Rezoning Application: 26-0558
Zoning Hearing Master Date: July 20, 2026
BOCC Land Use Meeting Date: September 22, 2026

1.0 APPLICATION SUMMARY

The applicant requests to rezone properties from Planned Development (PD) 12-0032 and AR (Agricultural Rural) to PD to allow Manufacturing (M) zoning district uses.

APPLICATION NUMBER: PD 26-0558

2.4 Proposed Site Plan (partial provided below for size and orientation purposes. See Section 8.0 for full site plan)

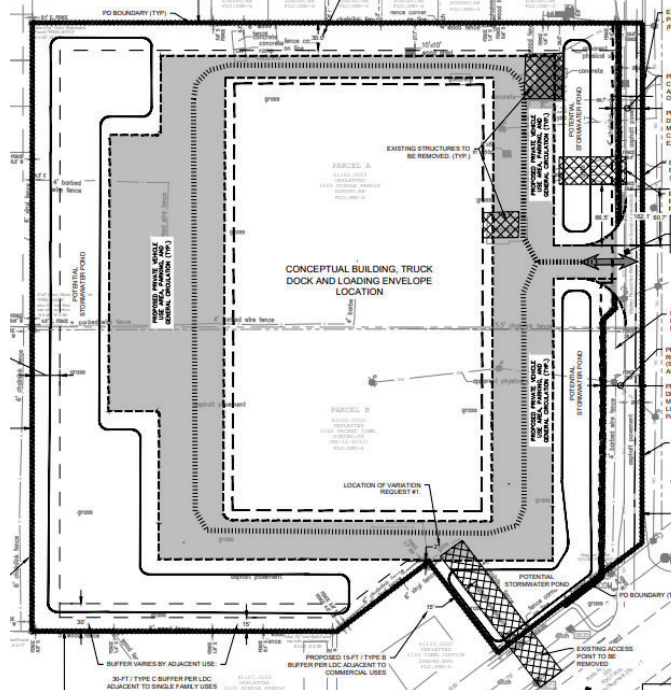
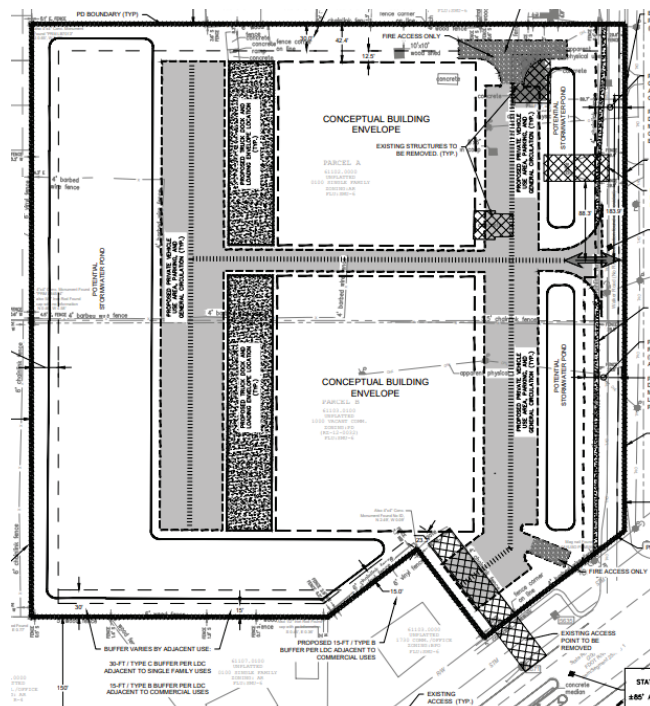
Under both options, the northern setback is not compliant with the 2:1 setback for the building height. However, the required 30-foot wide buffer with Type C screening is proposed, with enhanced tree plantings along the north (14-foot high live oak trees at 4-inches in caliper in lieu of 10-foot high evergreen shade trees at 2-inches in caliper). The applicant has offered conditions to mitigate for the non-compliant setback, including enhanced building design, loading and unloading hours, noise limits and exterior lighting restrictions.

The applicant has made proposals to address compatibility; however, staff is unable to find the request compatible due to the following:

- Northern building setbacks which do not meet the 2:1 setback for a building height of 45 feet. Option 1 reduces the setback by approximately 16 feet, while Option 2 reduces the setback by approximately 38 feet. Properties to the north are developed with 1-story single-family homes, oriented northwards placing rear yards adjacent to the warehouse facility. The building width may be as wide as 225 - 290 feet. Non-residential buildings abutting residential districts have the additional requirement of an increased setback (for every 100 feet) or an enhanced buffer option of an 8-foot high masonry wall with shade tree plantings, or a 6-foot high masonry wall with ornamental and shade tree plantings. This compatibility measure is not provided.

- The loading/unloading hours are limited and facility hours will allow 24-hour operations.
- Option 1 restricts load/unloading from the northern drive. However, this will still allow for truck circulation approximately 30 feet from the property line at all times. The loading/unloading area would be permissible from any façade. Option 2 removes the northern drive aisle, but places a fire-truck turn around within the buffer and locates the truck dock for loading/unloading 42.4 feet from the property line.

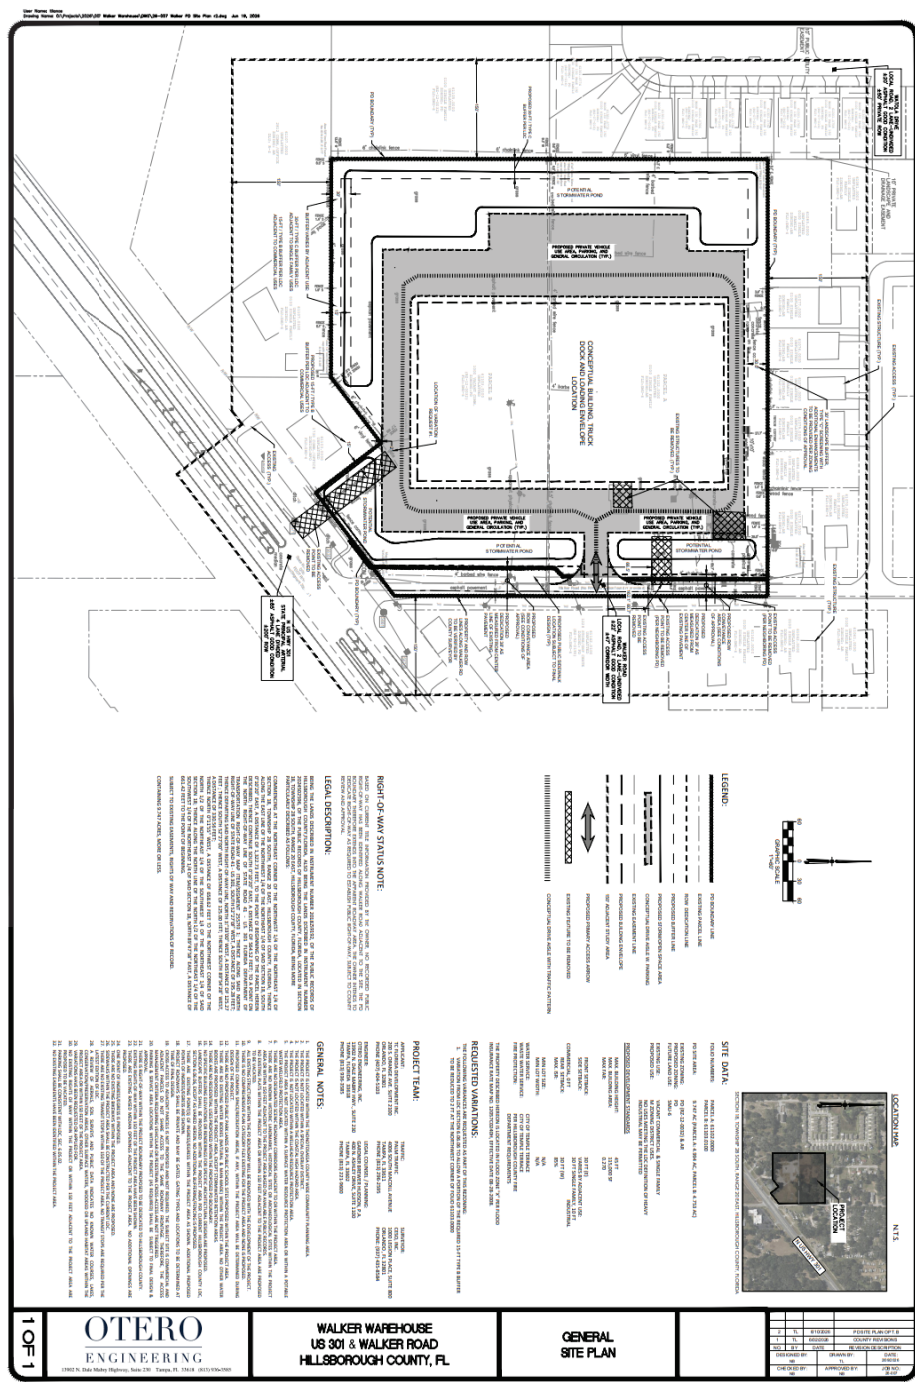
The applicant has requested two PD Variations:

- Option 1: Buffer reduction from 15 feet to 0 feet at the southeastern portion of the site adjacent to commercial property. Per the applicant's responses, the reduction is necessary for the site layout. The area of reduction is limited in area and necessary to provide the 30 foot wide buffer along the northern PD boundary.
- Option 2: Buffer reduction from 30 feet to 18 +/- feet at the northeastern portion of the site adjacent to residential property. Per the applicant's responses, the reduction is not within the full buffer and will be limited to fire truck use. This encroachment is a result of the Option 2 design with two free-standing buildings.

Staff is not supportive of the PD Variation requests, which could be resolved with a smaller development. Deviation from these regulations is not necessary to provide a more creative or innovative design, would not continue to meet the intent of the Land Development Code and would intensify the project's incompatibility with the adjacent residential.

CROSS-SECTION "S1"

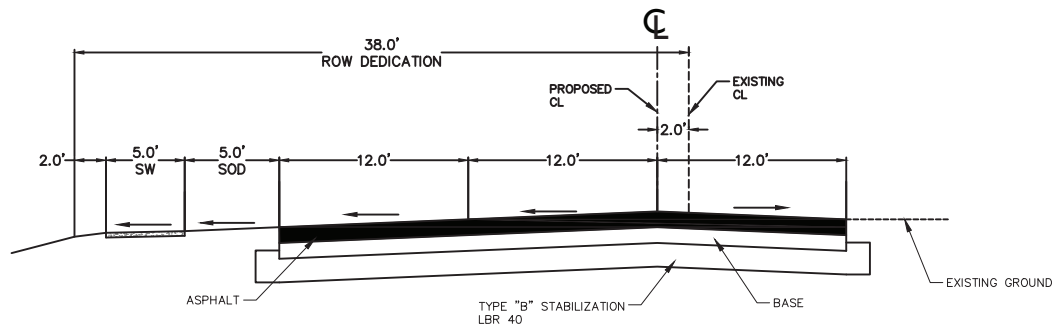
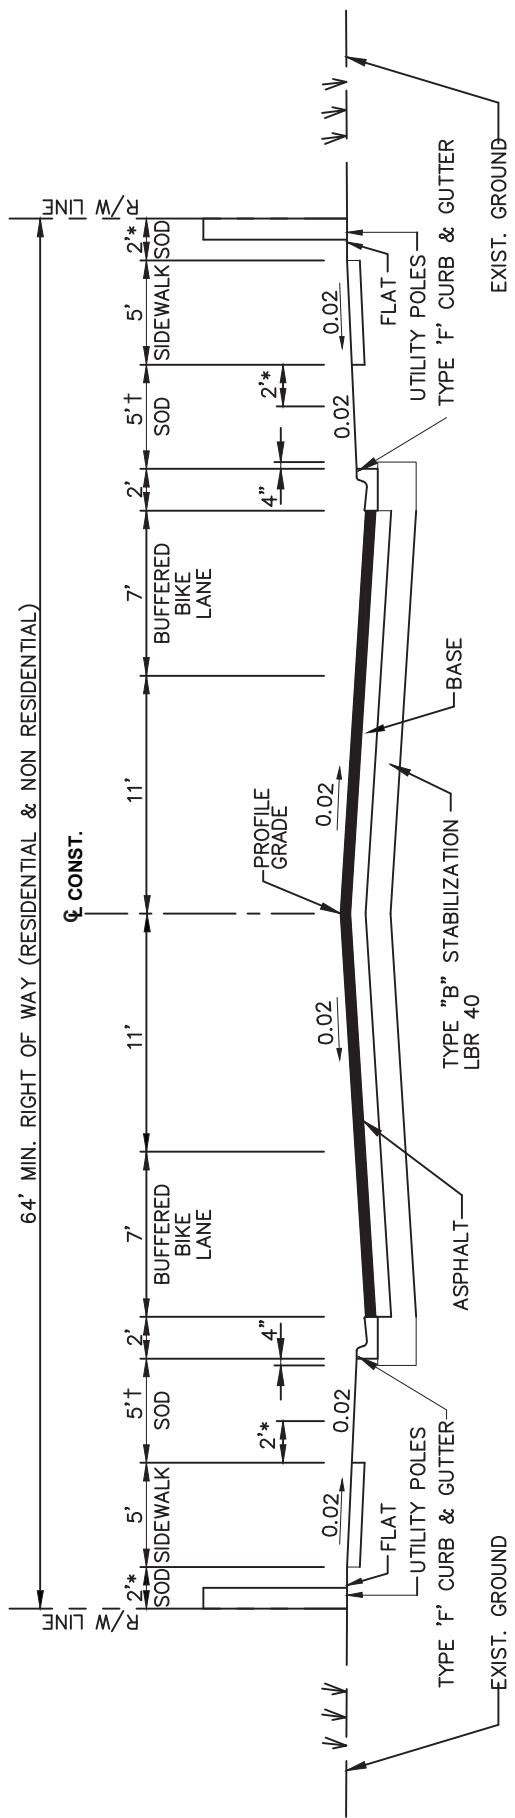
This request is a design exception to the Hillsborough County Transportation Technical Manual for Walker Road along the property frontage. The requested exceptions to the TS-4 typical section and the justification are as follows:

1. The TS-4 includes 11-foot travel lanes. The request is to provide 12-foot travel lanes and a 12-foot northbound left turn lane.
2. The TS-4 includes a 7-foot buffered bike lane. The request is not to provide a 7-foot buffered bike lane.
3. The TS-4 incorporates an F type curb. Given this section of Walker Road does not have an F type curb within the immediate area, it is requested to maintain the existing section without an F type curb.

4. The TS-4 section includes a 5-foot grass strip between the sidewalk and the curb. The request is to provide the 5-foot grass strip between the edge of pavement and the sidewalk.
5. The TS-4 section includes a 5-foot sidewalk on both sides of the roadway. The request is to provide a 5-foot sidewalk on the west side of the roadway along the property frontage.
6. The TS-4 includes 2 feet from back of sidewalk to the right of way line. This will be provided along the western side of the roadway.
7. A ROW dedication of approximately 38 feet from the existing centerline will be required along the project frontage from US 301 to the project driveway and will taper to approximately 26 feet of ROW dedication at the northern property line.

I have found the attached Section 6.04.02.B. Administrative Variance (AV) and Design Exception (DE) for PD 26-0558 APPROVABLE.
